VENDOR SERVICE PUBLICATION

**SUBJECT:** Hartzell Propeller Products Division, Service Advisory No. 39, dated August 18, 1986

**Inspection and Reinforcement of B.F. Goodrich  
Propeller De-Ice Terminal Clamp Assembly P/N  
3E1883-2.**

NO. - E-85-73  
ISSUED - 6-6-86  
REVISED -

FIGURE 1a

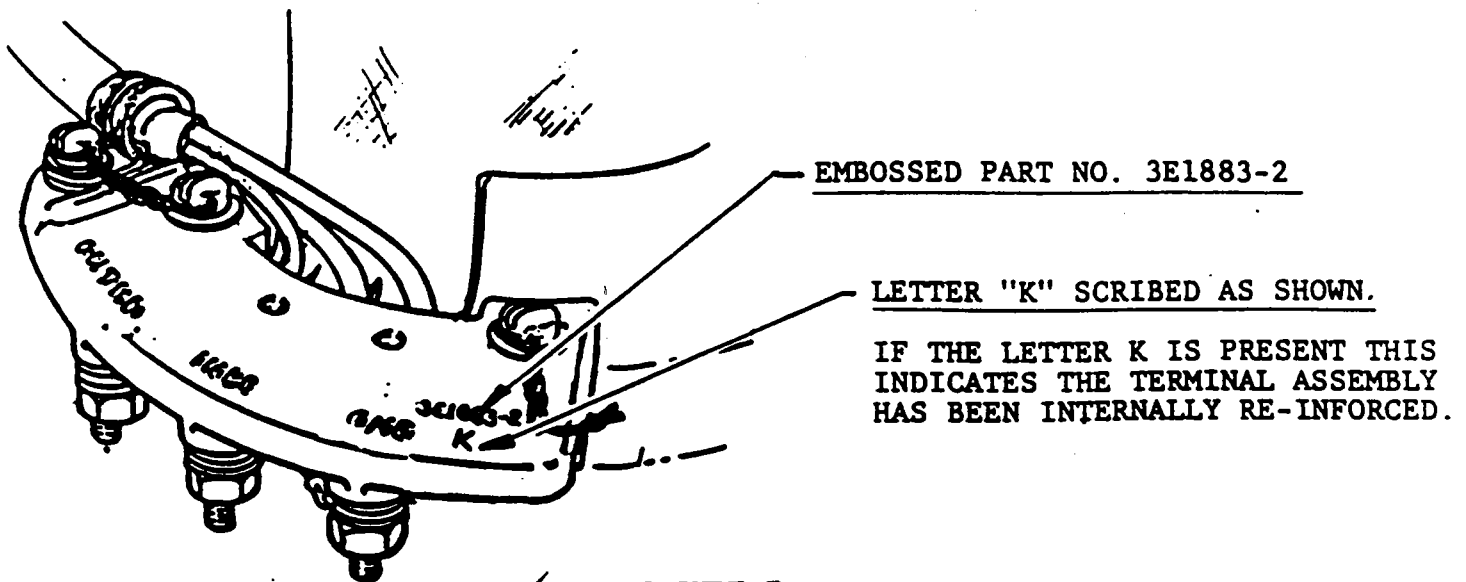
- DISCUSSION: a) If the terminal clamp assembly is black and is identified as  
(CONTINUED) part number 3E1883-2, it is factory reinforced.
- b) If the terminal clamp assembly is lightgray and has the letter K scribed below the part number (Ref. figure 1a), it is factory reinforced.

- a) Visually inspect each terminal clamp assembly in the area below the embossed 3E1883-2 part number. If the Letter 'K' is scribed as shown in Figure 1-a or if the terminal clamp is black and identified as part number 3E1883-2 nothing further is required. (Ref: DISCUSSION)
- b) If the Letter "K" is not present and the clamp is lightgray in color, visually inspect the assembly for any noticeable cracks. (Ref. Figure 1-b)

FIGURE 1b.

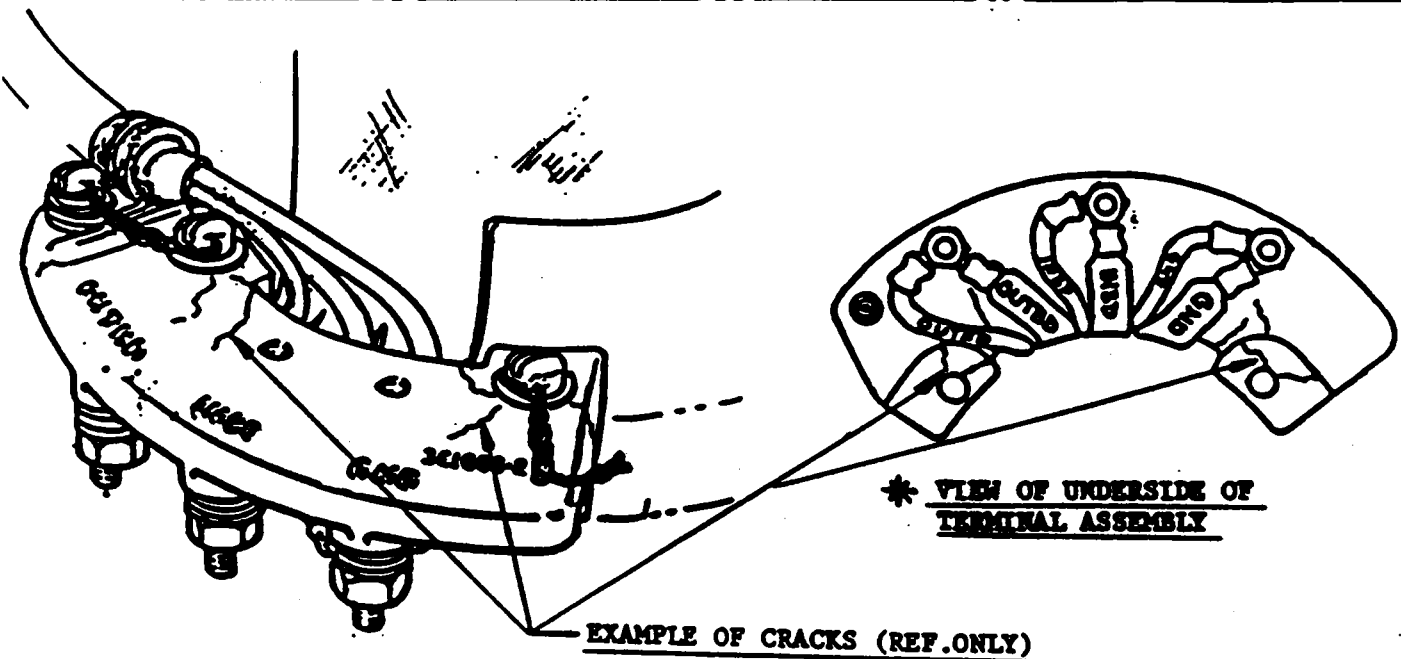
\* TO INSPECT THE UNDERSIDE OF THE TERMINAL ASSEMBLY:

1. REMOVE SAFETY WIRE.
2. LIFT THE ASSEMBLY AND INSPECT AROUND THE ATTACHMENT HOLES AND STANDOFF PADS. IT IS NOT NECESSARY TO REMOVE THE LEADS AT THIS TIME. (FOR REINSTALLATION SEE FIGURES II AND III.)

NOTE: IF THE TERMINAL ASSEMBLY HAS ONE OR MORE CRACKS AS SHOWN IN THE EXAMPLE THE ASSEMBLY MUST BE REPLACED.

If any sign of cracking or separation is present, the terminal assembly must be replaced. If the terminal assembly is sound, i.e. no cracks, it is not necessary to replace the assembly as it can be reinforced using the reinforcement kit.

**FIGURE II**

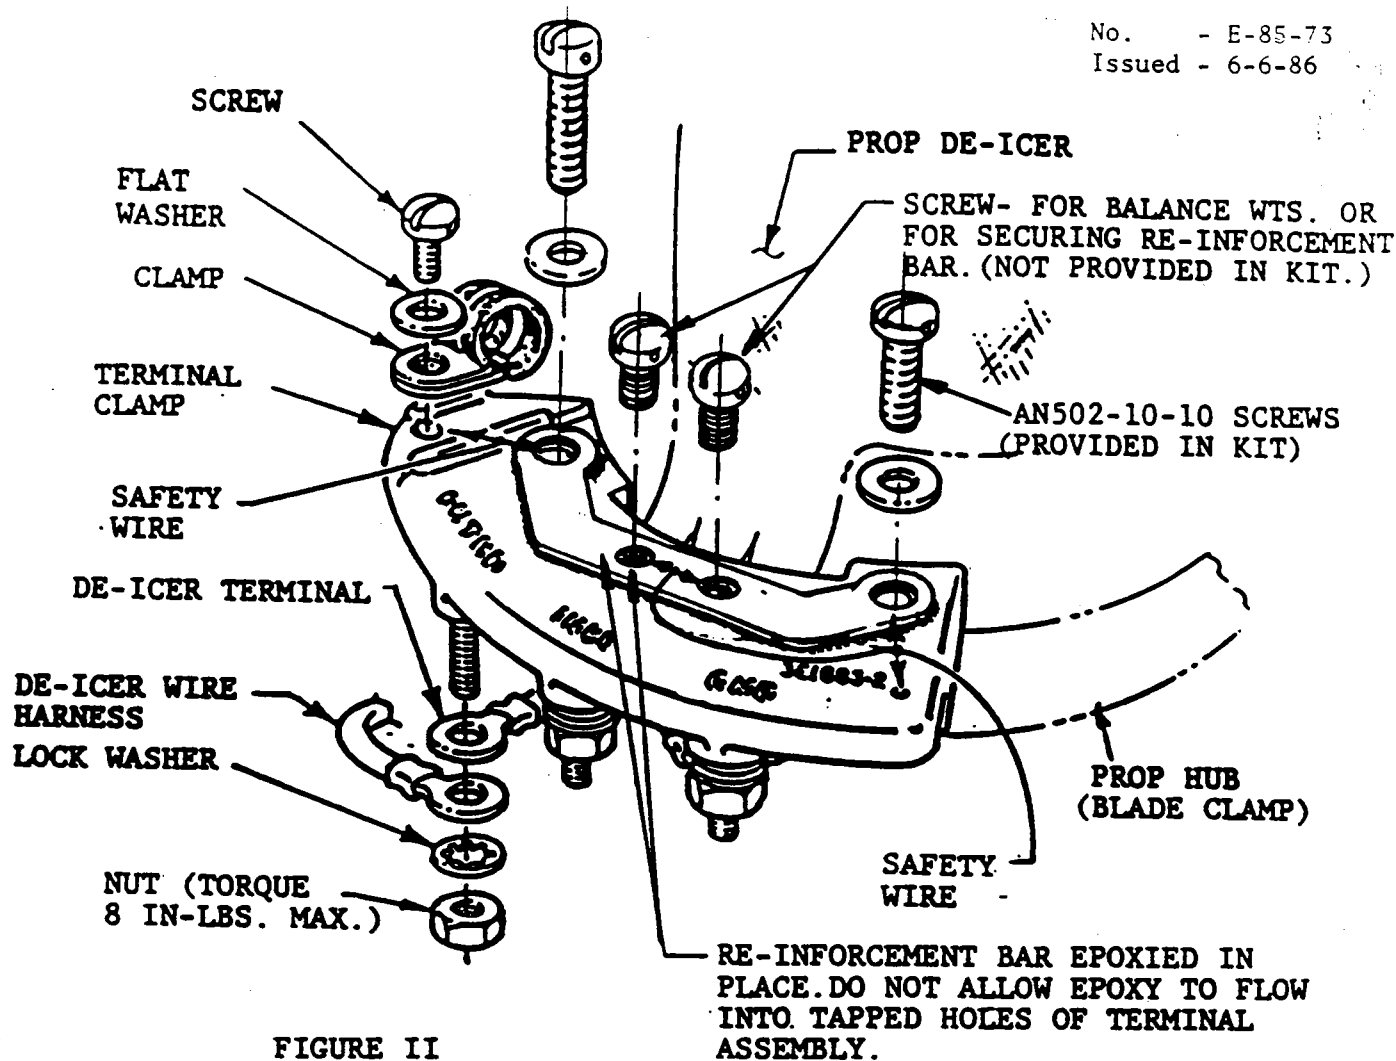
2.2 Procedure (Ref: Figure II)

- a) Remove the terminal clamp assembly, disconnect the de-icer and de-icer wire harness. Remove any balance weights attached to the terminal clamps.

- b) Thoroughly clean bonding surfaces. Recommended cleaning agents: Toluol, Isopropyl Alcohol, or MEK (Methyl Ethyl Ketone).
- c) Prepare the epoxy as described on the epoxy packet.
- d) Apply the mixed epoxy to the surface of the reinforcement bar that is to mate with the terminal clamp assembly.

- e) Position the reinforcement bar on the terminal clamp assembly. Ensure that all the holes on the reinforcement bar properly align with those on the terminal clamp assembly. No epoxy is permitted in the tapped holes of the terminal assembly.
- f) Allow 30 minutes for the epoxy to set. The assembly is then ready for reinstallation.

- a) Thoroughly clean top of prop blade clamp mounting surface to remove any foreign materials.
- b) Connect de-icer leads and wire harness leads as shown in Figure II and position terminal assembly on prop blade clamp. Care should be taken to avoid crossing any leads.
- c) Install attaching screws and washers. (When re-installing terminal clamp assemblies that have not been reinforced use the original mounting screws and washers.) Longer screws are provided in the reinforcement kits and must be used to attach any terminal clamp assembly that has been reinforced per this Service Bulletin. The original washers can be used. Check to see that the leads are not pinched between the terminal assembly and blade clamp. (Ref: Figure III) Tighten screws. Torque to 15-20 in./lbs. and safety wire.

**NOTE:** If prop balance weights were present on the original terminal clamp assembly, they must be reinstalled on the new assembly in the same manner in which they were removed. The ends of the screws securing these balance weights must not protrude through the terminal assembly and contact the leads or the blade clamp. If balance weights are not required install two screws MS35275-40 or equivalent (Ref: Figure II) to secure reinforcement bar. Safety wire after installation.

**FIGURE III**

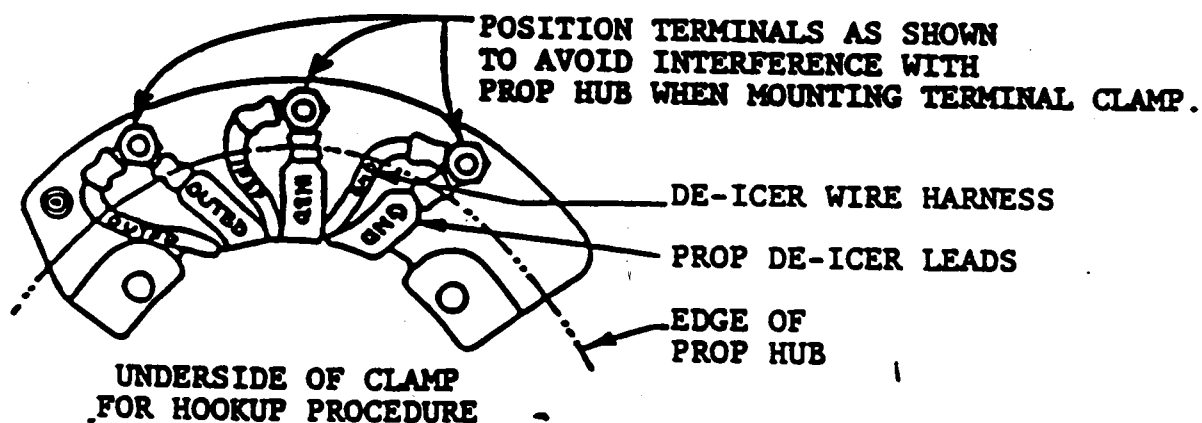
**CAUTION:** DO NOT PLACE WASHERS OR PROP BALANCE WEIGHTS BETWEEN THE PAD OF THE TERMINAL CLAMP ASSEMBLY AND PROP BLADE CLAMP.
